RE: RM of Alexander Wastewater Lagoon, Environment Act Proposal
File number: 5800.00
Response to Request for Additional Information

EFFLUENT DISCHARGE ALTERNATIVE

FEBRUARY 2016 FIGURE A-1 REV: A

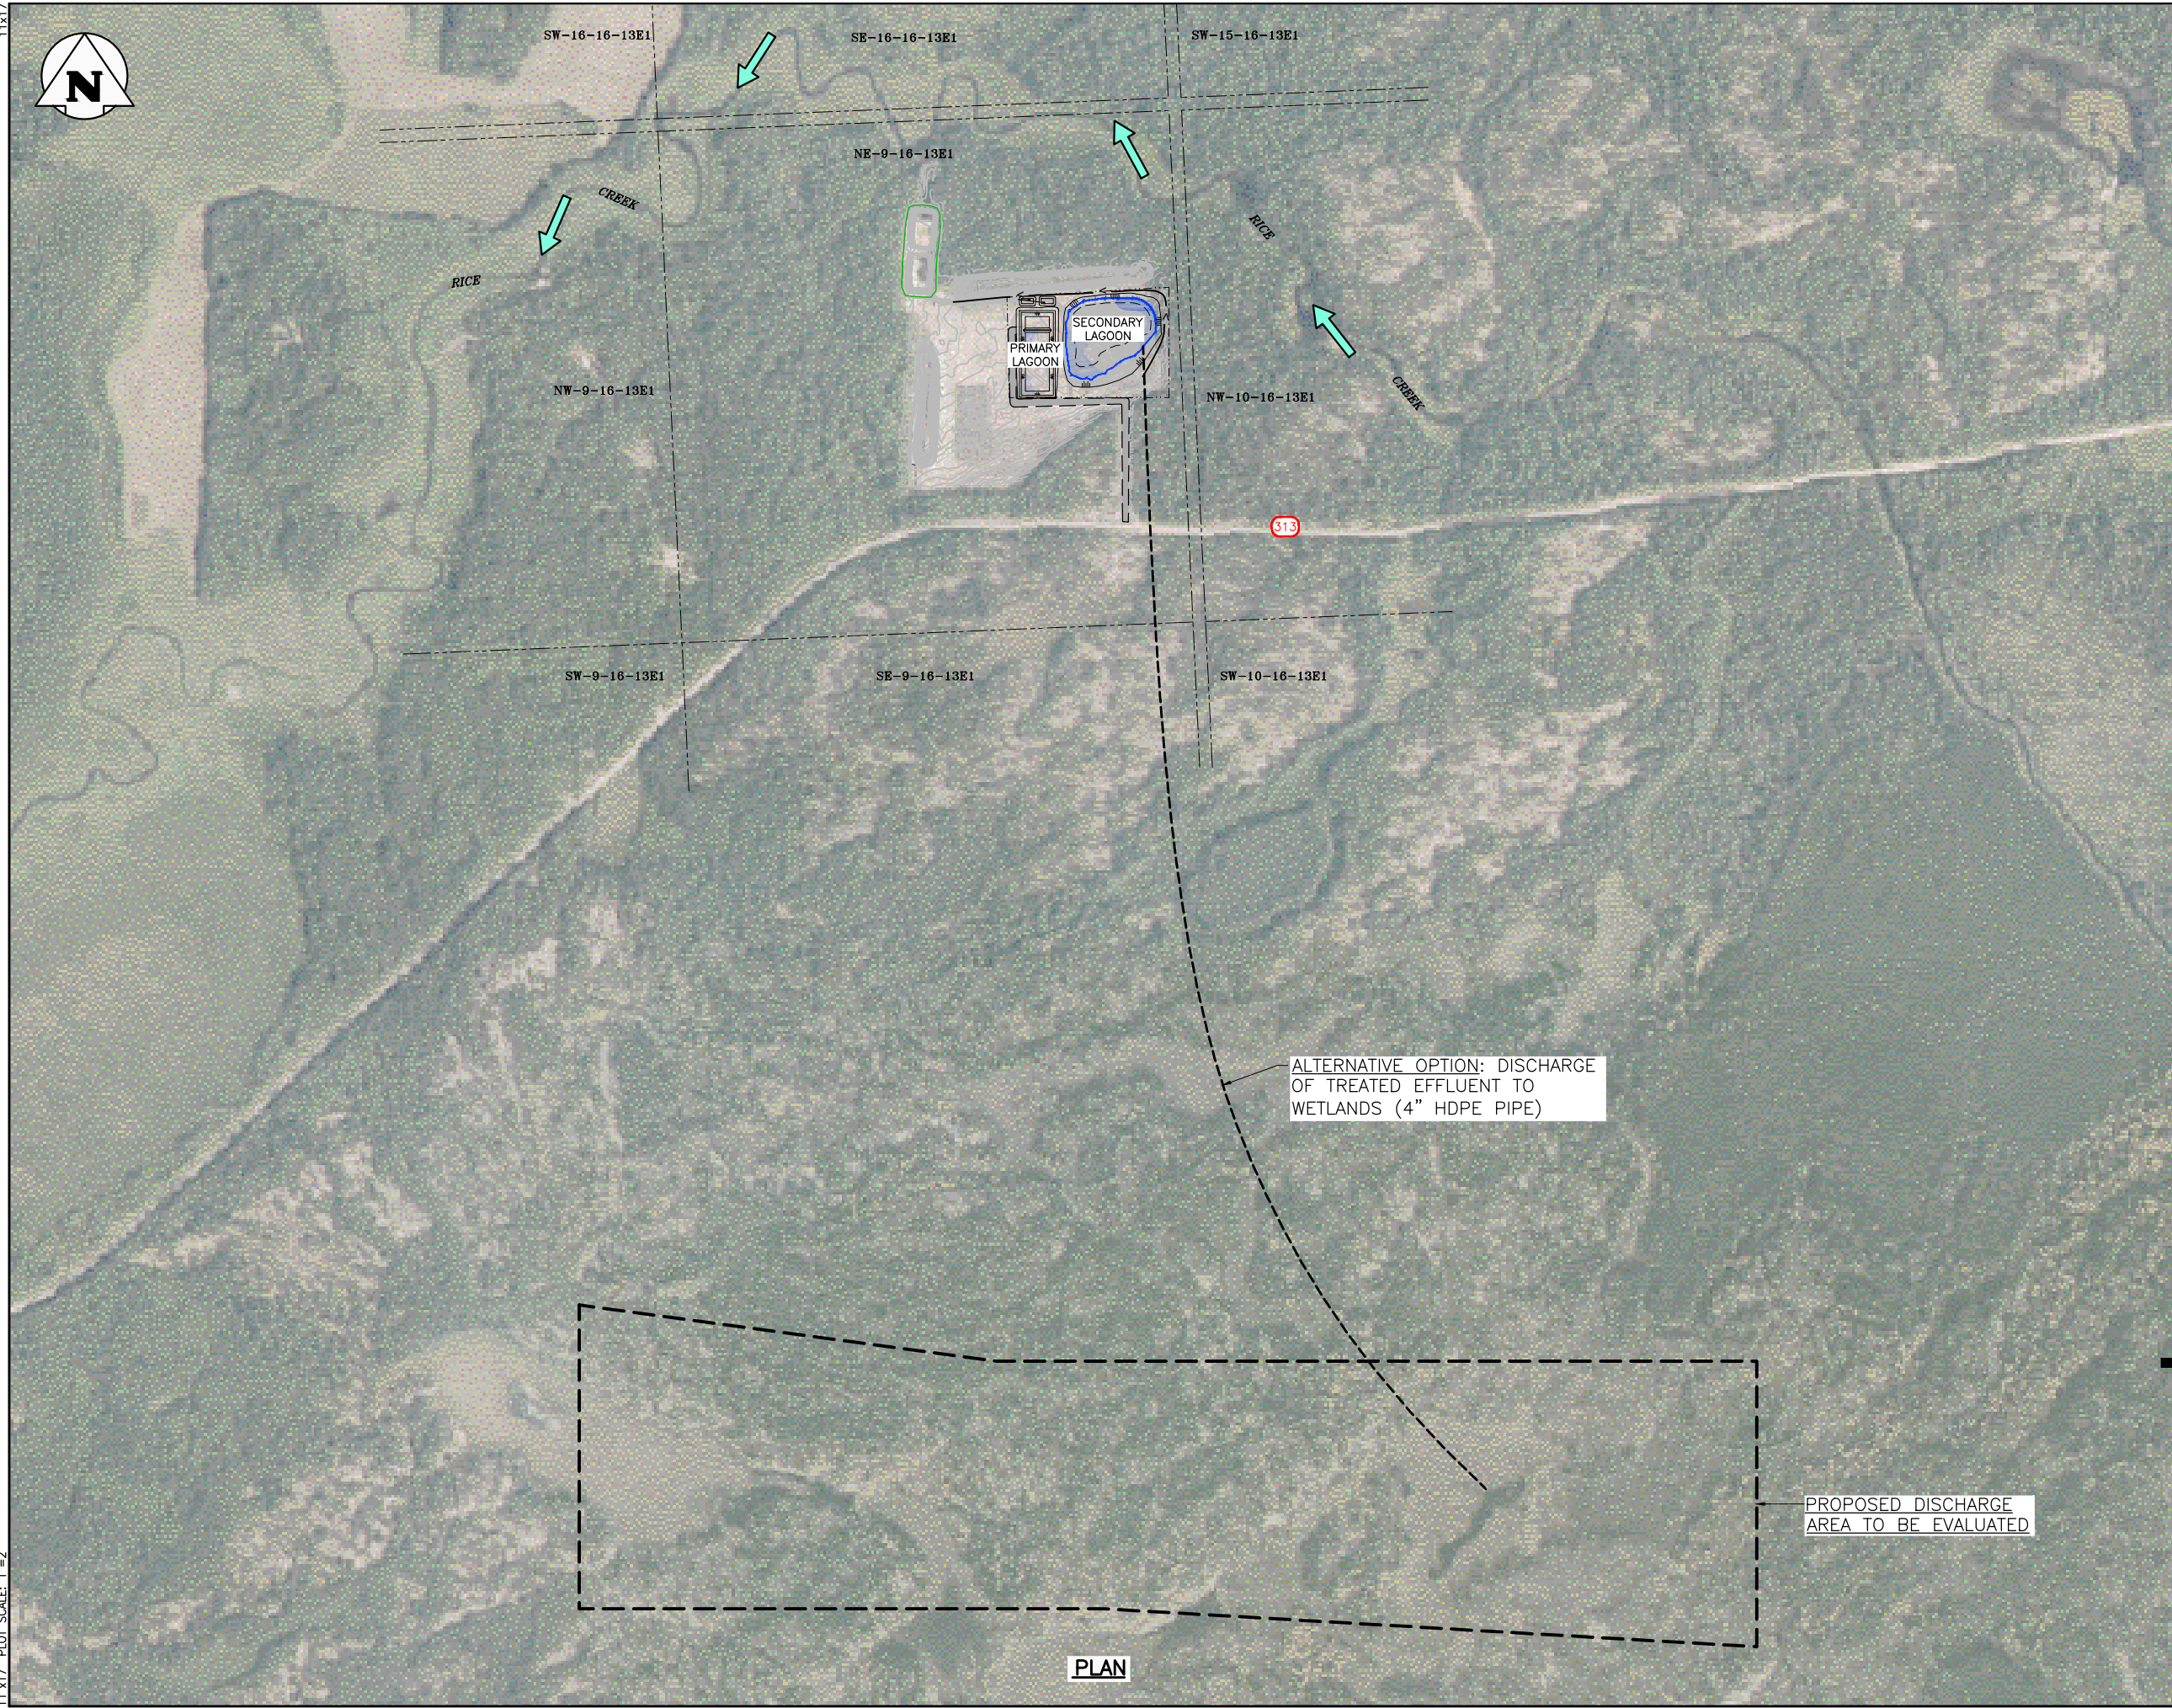
1. The wetland restoration assessment was part of a previous study by Manitoba Hydro and is unrelated to the lagoon design.
2. The response to Item 2 will also apply to Items 5, 6, 7, and 8. These items request commentary and/or additional information to support the application of treated effluent to the forested area west of the lagoon site.

An alternative option that we are now proposing is to discharge south of the lagoon site into a large wetland area approximately 1.5 km south of the PR 313 (see attached Appendix A). This would provide an area for significant nutrient uptake and overall dilution prior to entering the Rice Lake river system. The exact location of the discharge would require field selection of an optimal location. Based on this preliminary review, there appear to be several potential wetlands areas to the south of PR 313. It should be understood that the discharged effluent would meet the required effluent discharge criteria within the *Manitoba Water Quality Standards, Objectives, and Guidelines Regulation* (MWQSOG) prior to discharge.
